## Report to Development Permit Panel

**Re:** Application by 1058085 BC Ltd. for a Development Permit at 10431 No. 5 Road

**Annotated Excerpt from the Draft Minutes from  
Advisory Design Panel Meeting**

**DP 20-910008 – ARTERIAL ROAD COMPACT DUPLEX DEVELOPMENT**

1  
A4 CONVERTIBLE UNIT PLAN  
3/16" TO 1'-0"

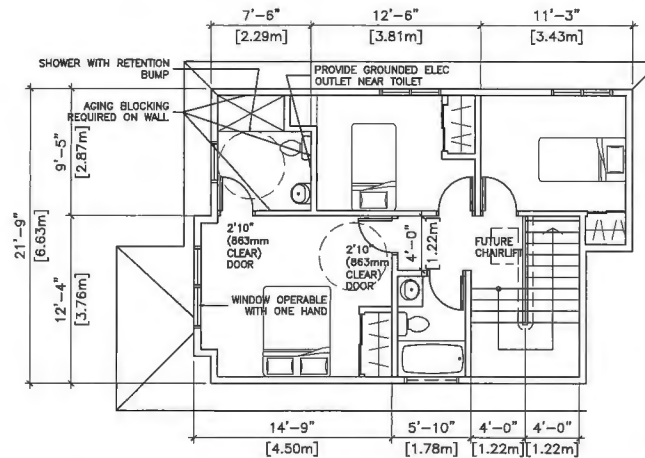
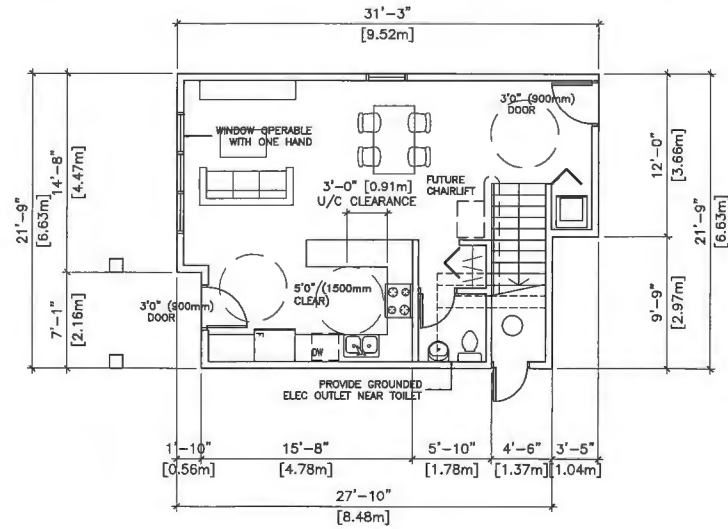
- appreciate the thorough and informative presentation of the applicant;
- appreciate the details provided by the applicant with regard to the accessibility features of the convertible units, e.g. windows operable with one hand and provision for future installation of chairlift;
- appreciate the accessible walkway beside the garage to provide space for loading of a wheelchair into a vehicle;
- appreciate the provision of electrical outlets at the top and bottom of staircases and other areas in the convertible units; however, also consider installing grounded electrical outlets near the toilet in the washroom on the ground floor and at the accessible bathroom on the second floor to allow for the use of specialized toilets and lift mechanisms;

- in lieu of a shower lip, consider sloping the shower floor at 1.5 percent with one retention bump for wheelchair accessibility and water drainage;

***Grounded electrical outlet noted on drawings A4***

***Changes added to drawings A4***
